DUKE ENERGY CORPORATION

OCONEE NUCLEAR STATION

TECHNICAL SPECIFICATIONS
MARKED UP COPY

Technical Specification Change:

FIGURE 1

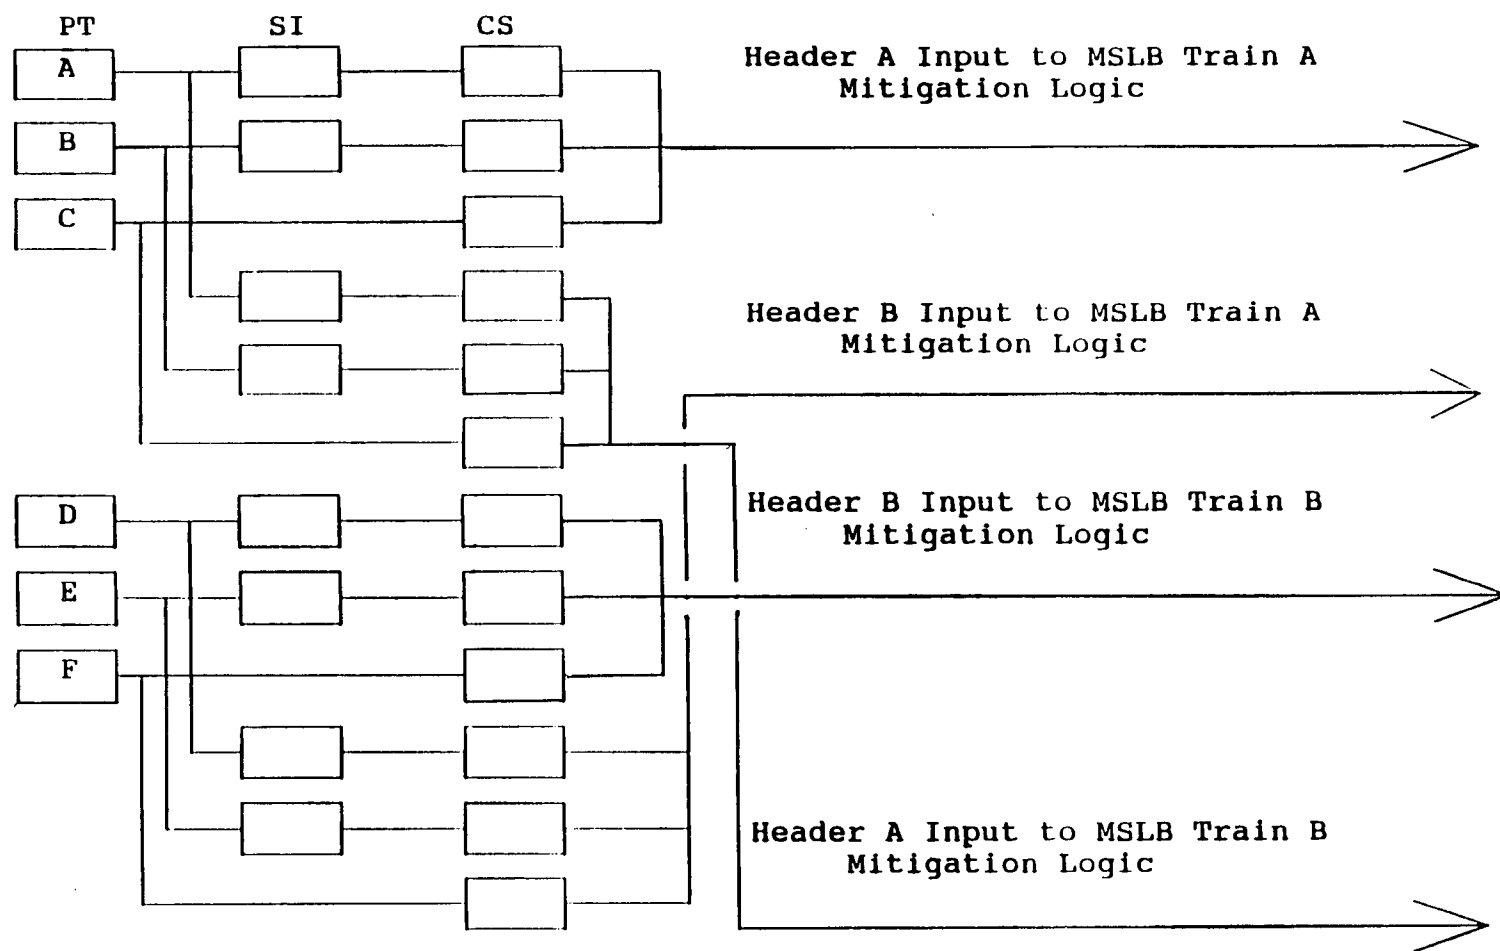
A new pressure transmitter will be installed on each steam header. These new pressure transmitters, in addition to two existing pressure transmitters per steam header, will each feed a steam pressure signal to a signal isolator (when used) and current switch. These current switches will be calibrated to provide an ON/OFF signal at the desired setpoint for actuation of the feedwater isolation circuitry. A pressure transmitter and its associated signal isolator(s) and current switch(es) constitute a MSLB detection analog channel. A block diagram of the MSLB detection analog circuitry is provided in Figure 1.
